DSP-19032

SAFStor Temple Hills

STAFF REPORT

SUBJECT: Detailed Site Plan DSP-19032
Departure from Design Standards DDS-655
Departure from Parking & Loading Standards DPLS-470
Type 2 Tree Conservation Plan TCP2-025-2019
SAFStor Temple Hills

BIRD'S-EYE VIEW WITH APPROXIMATE SITE BOUNDARY OUTLINED

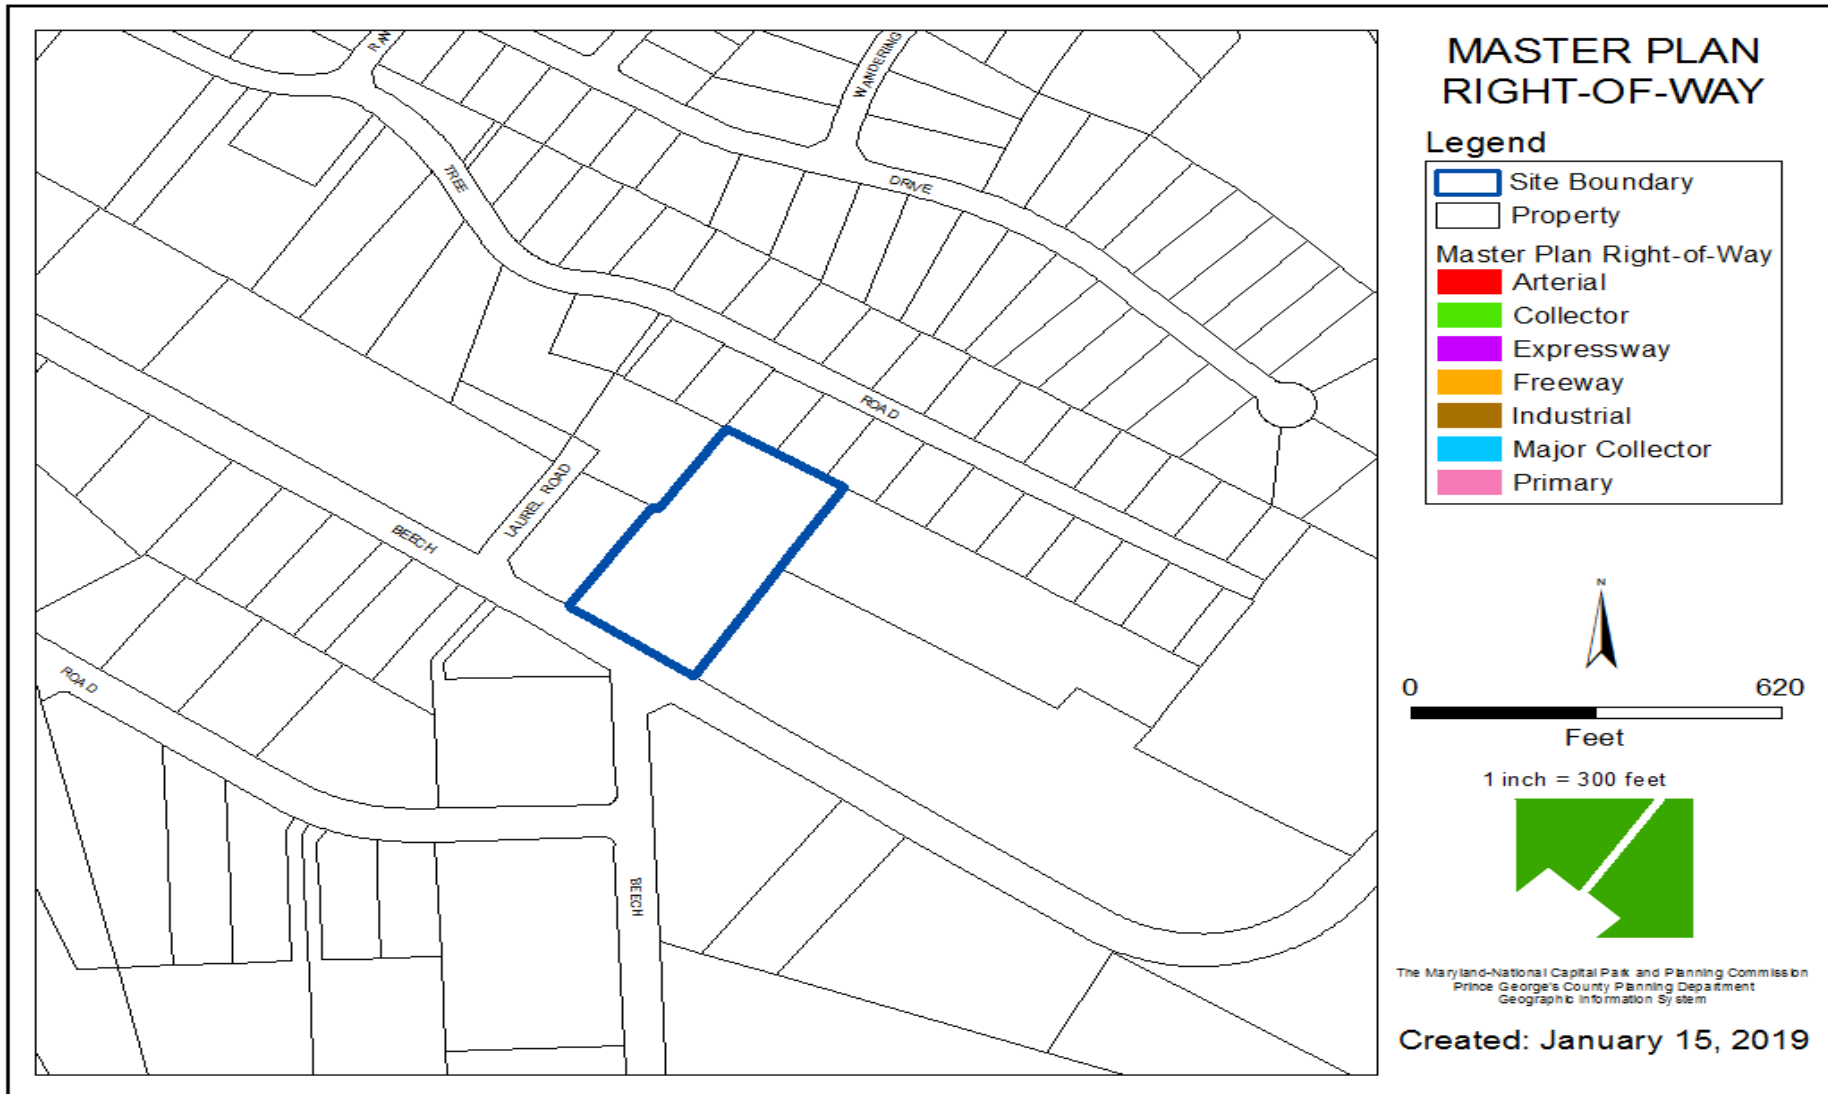
The DSP shows an illegally constructed, residential garage along the northern boundary of the property that appears to serve the property to the north. Staff advised the applicant that the residential garage needs to be removed or relocated from the property as the use is not permitted in the I-1 Zone and there is no record of the structure being approved by the permitting agency for construction. Therefore, a condition is included in the Recommendation section of this report to remove or relocate the structure from the subject property.

**Illegally
constructed
garage**

- e. Indicate that the illegally constructed garage is to be removed or relocated from the property.
 - f. Revise the sign package to complement the architectural typology.

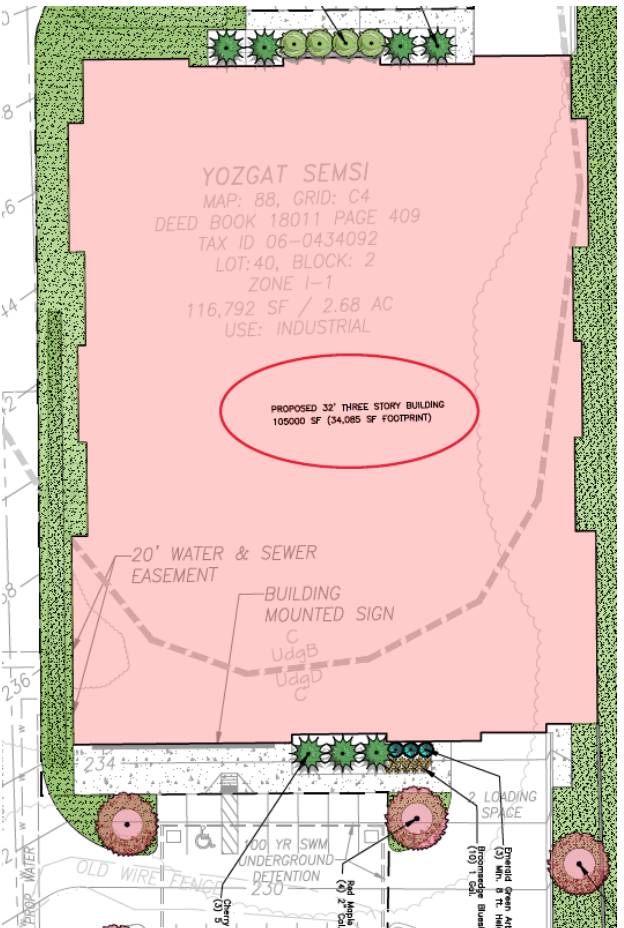
2. Applicant has not provided an approval sheet.
3. Applicant shows 21 spaces required but the actual required parking is 22 spaces. Applicant must round up to the next whole space. See tabulation below:

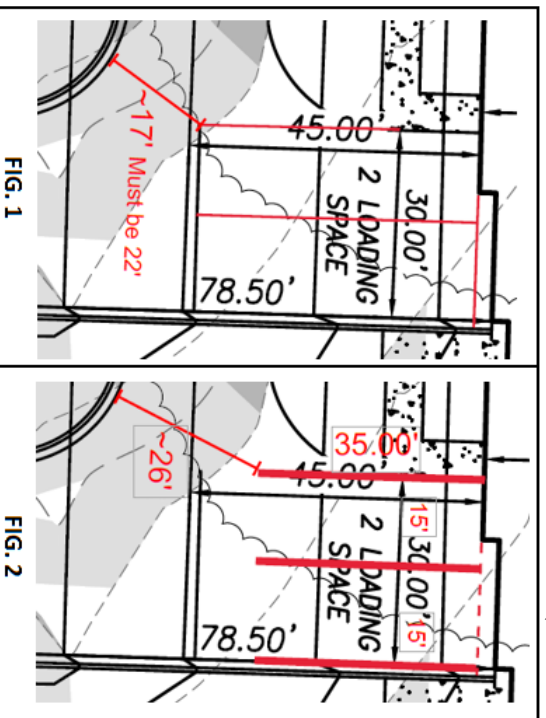
4. Rotate the text on Sheet 3 of 8 (circled in red in below image) 90 degrees clockwise:

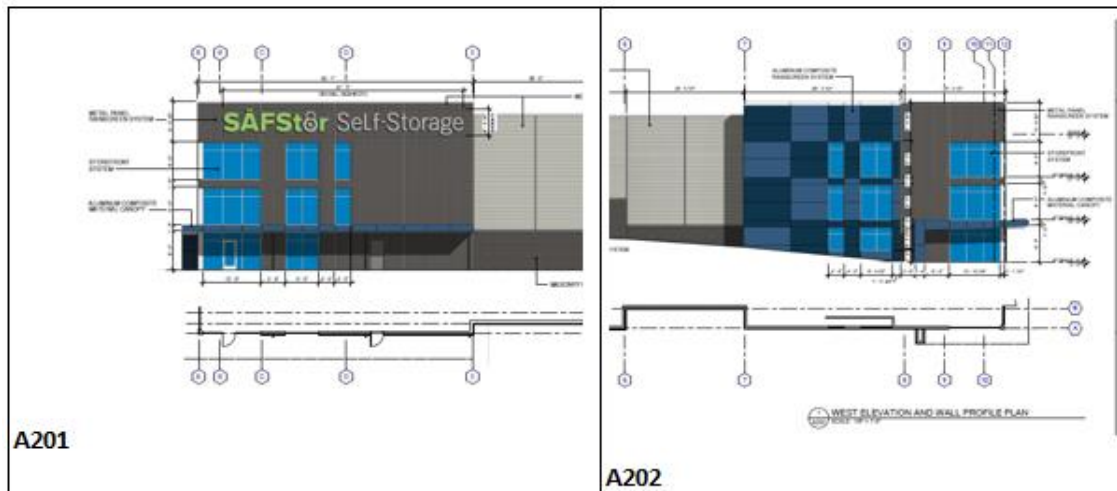
6. As seen from the below excerpt of Exterior Elevation Sheets A201 & A202, the glass storefront, shown in blue, exposes the entrances to the individual indoor storage units to the street. Per Sec. 27-475.04(a)(1)(A) & (B), this is not permitted:

- (A) No entrances to individual consolidated storage units shall be visible from a street or from adjoining land in any Residential or Commercial Zone (or land proposed to be used for residential or commercial purposes on an approved Basic Plan for a Comprehensive Design Zone, or any approved Conceptual or Detailed Site Plan).
- (B) Entrances to individual consolidated storage units shall be either oriented toward the interior of the development or completely screened from view by a solid wall, with landscaping along the outside thereof.

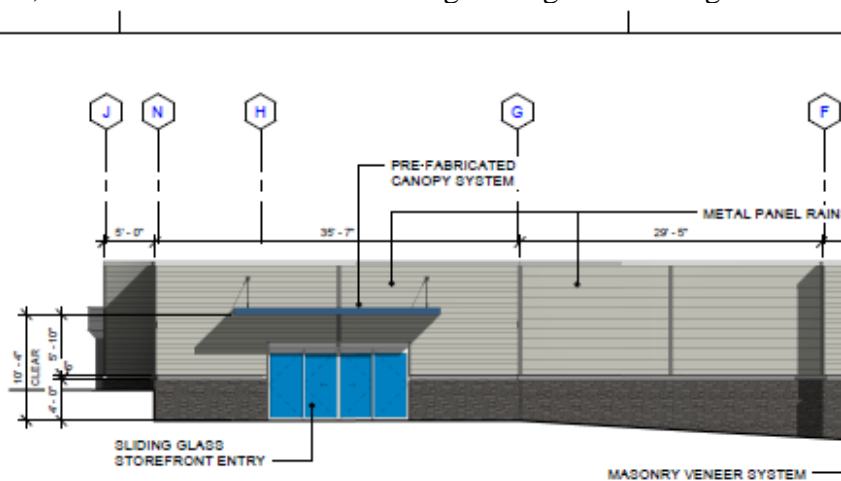
7. On Elevation Sheet A202, per excerpt shown below, the entry should not be labeled “Storefront”, as this is the rear of the building. Change to “Sliding Glass Rear Entry”.
